**Glenageary Gate LRD, Glenagery, Dun
Laoghaire, Co. Dublin**

Stage 1 Storm Water Audit

212178-PUNCH-XX-XX-RP-C-0002-SWA

60690914-ACM-00-00-DR-CE-10-0540

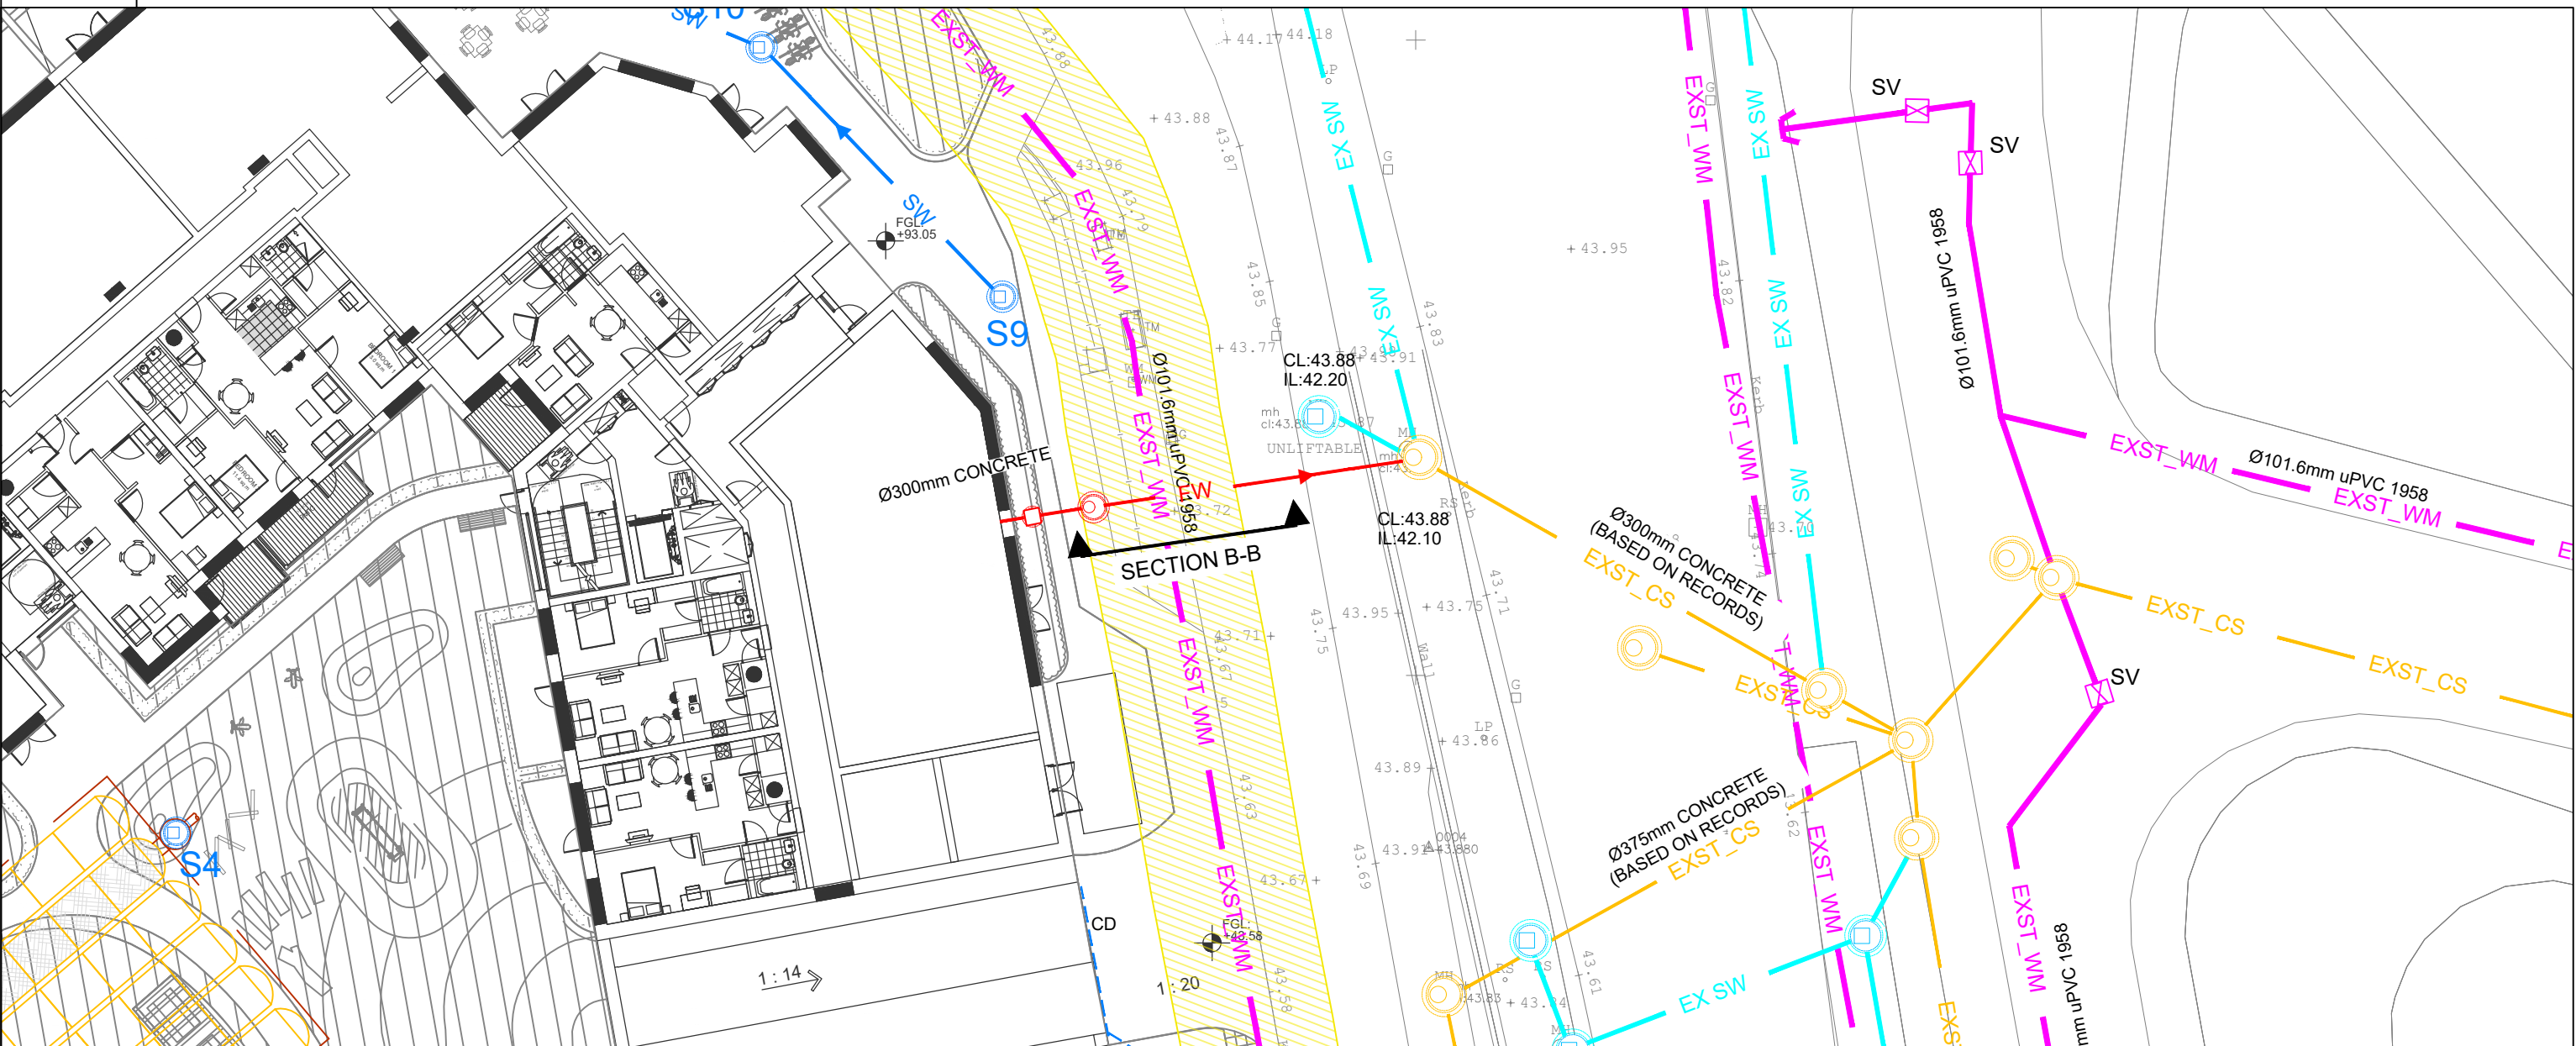
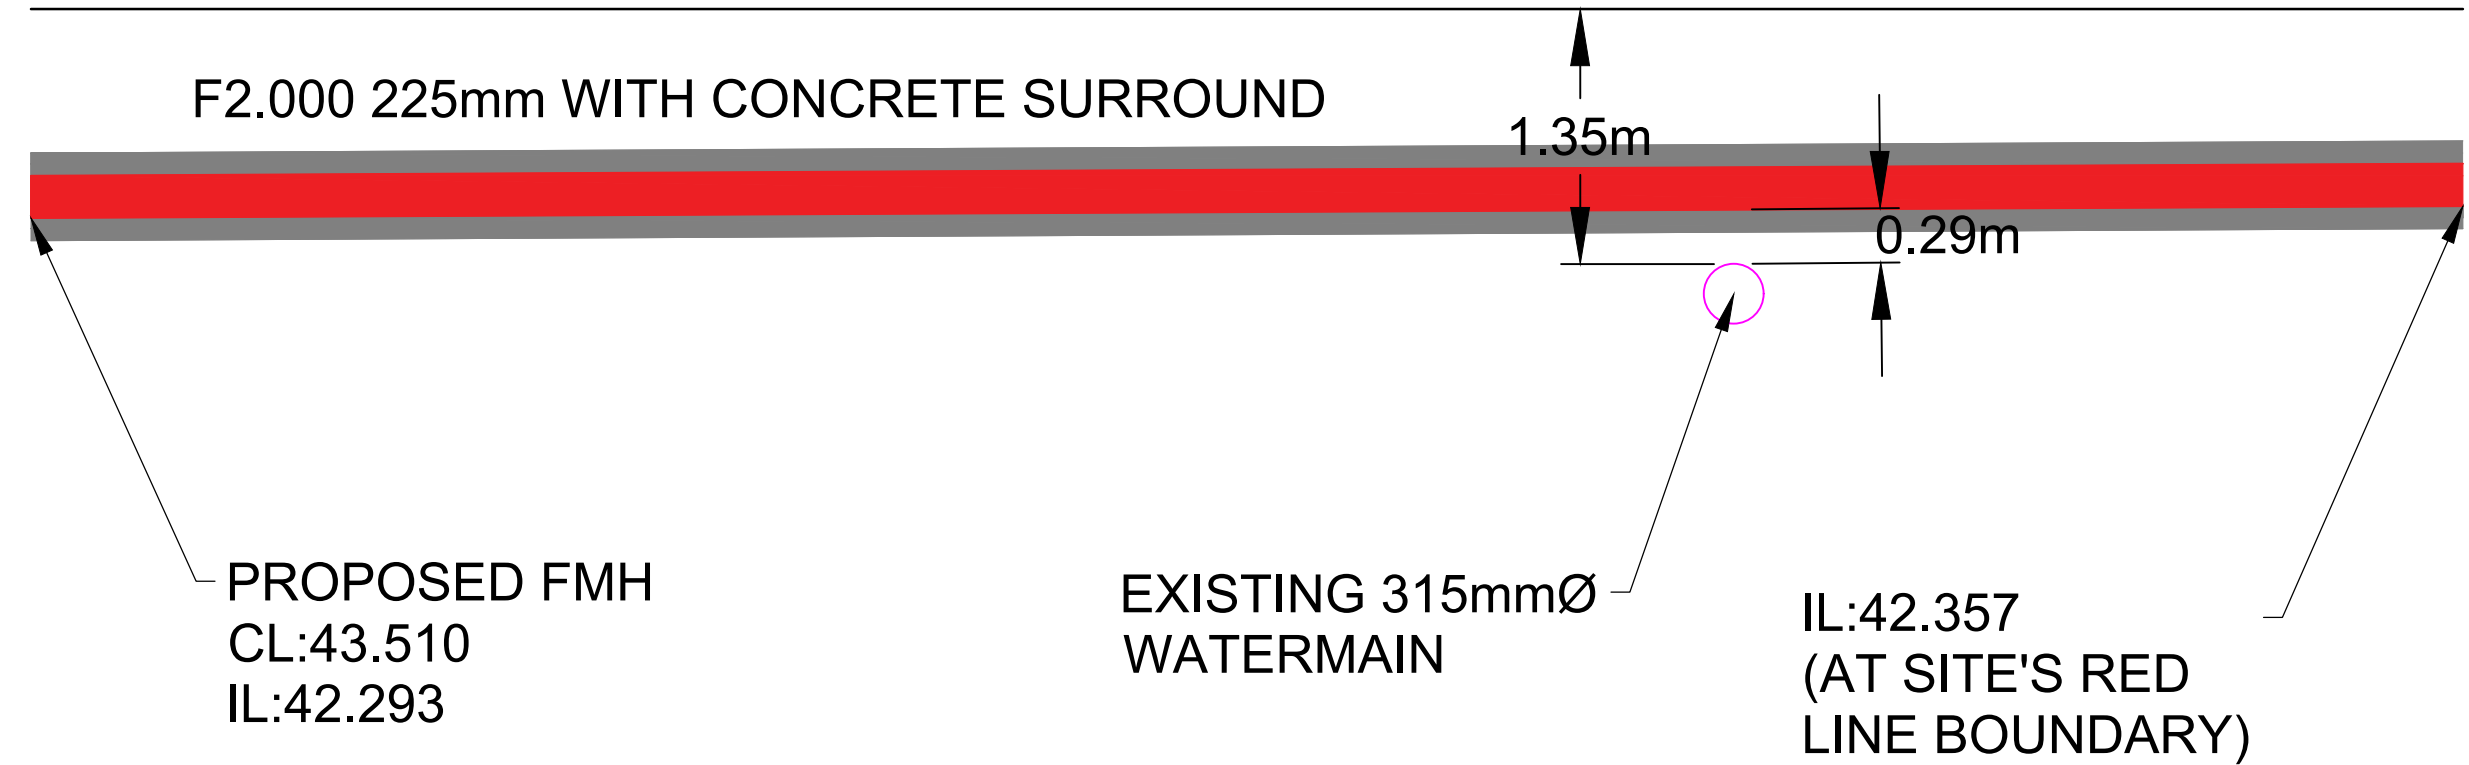
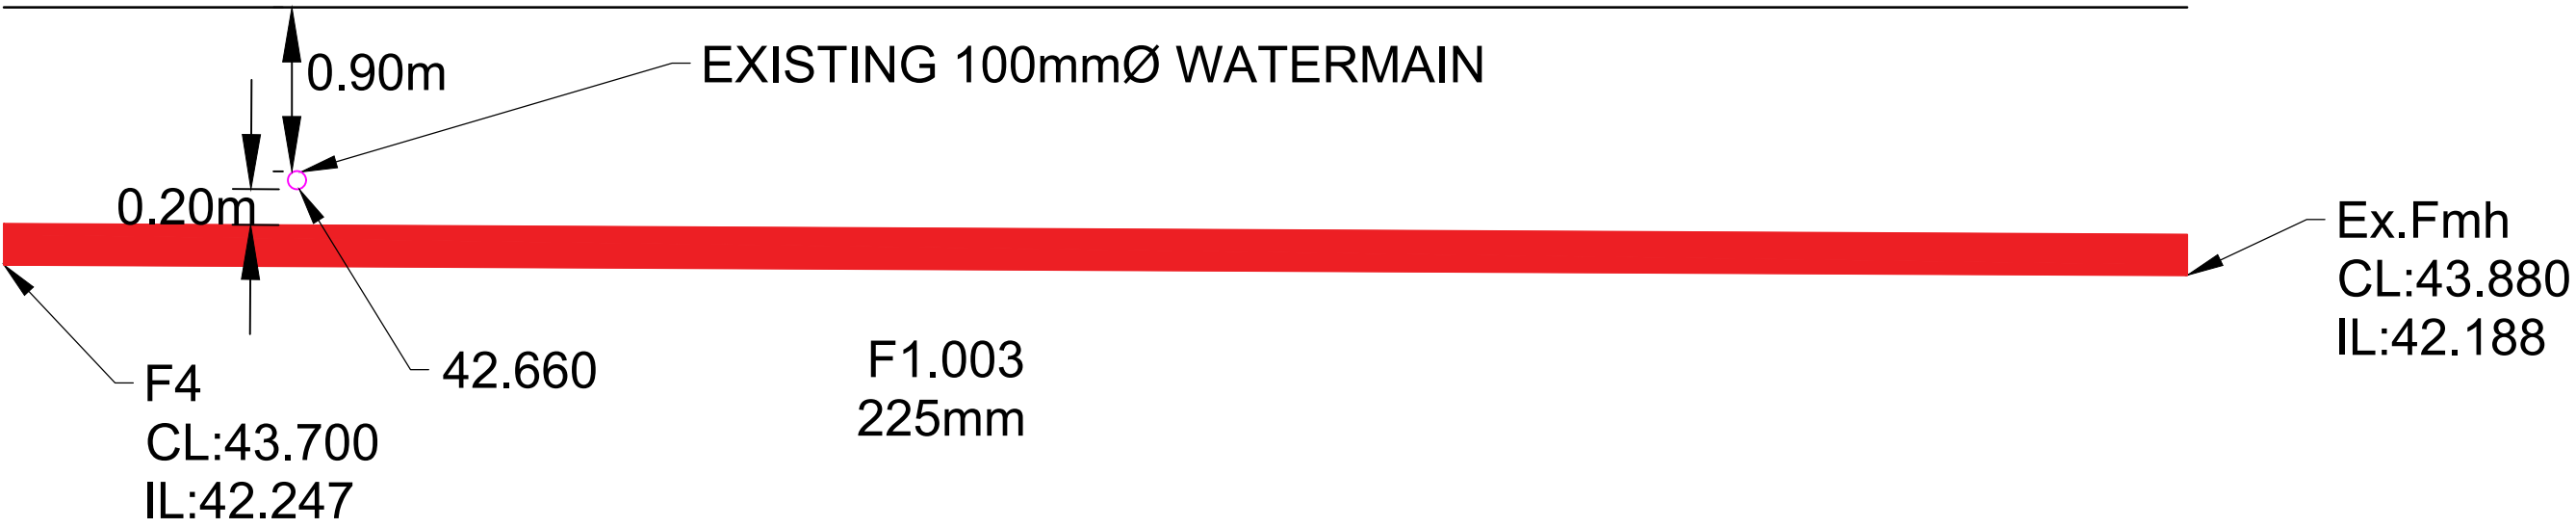
2.1.4	Utility Clash Check The Scheme Designer must undertake a utilities clash check to ensure all utilities' vertical and horizontal separation distances can be provided throughout the scheme. The Scheme Designer should demonstrate this with cross-sections at critical locations such as junctions, site thresholds and connection points to public utilities. Minimum separation distances must be in accordance with applicable Codes of Practice.	Scheme designer to confirm.

2.1.4	The Scheme Designer must undertake a utilities clash check to ensure all utilities' vertical and horizontal separation distances can be provided throughout the scheme. The Scheme Designer should demonstrate this with cross-sections at critical locations such as junctions, site thresholds and connection points to public utilities. Minimum separation distances must be in accordance with applicable Codes of Practice.	Scheme designer to submit evidence of utility clash check with cross-sections.	Please refer to the MicroDrainage long sections and crss section's added to drawings.	Yes
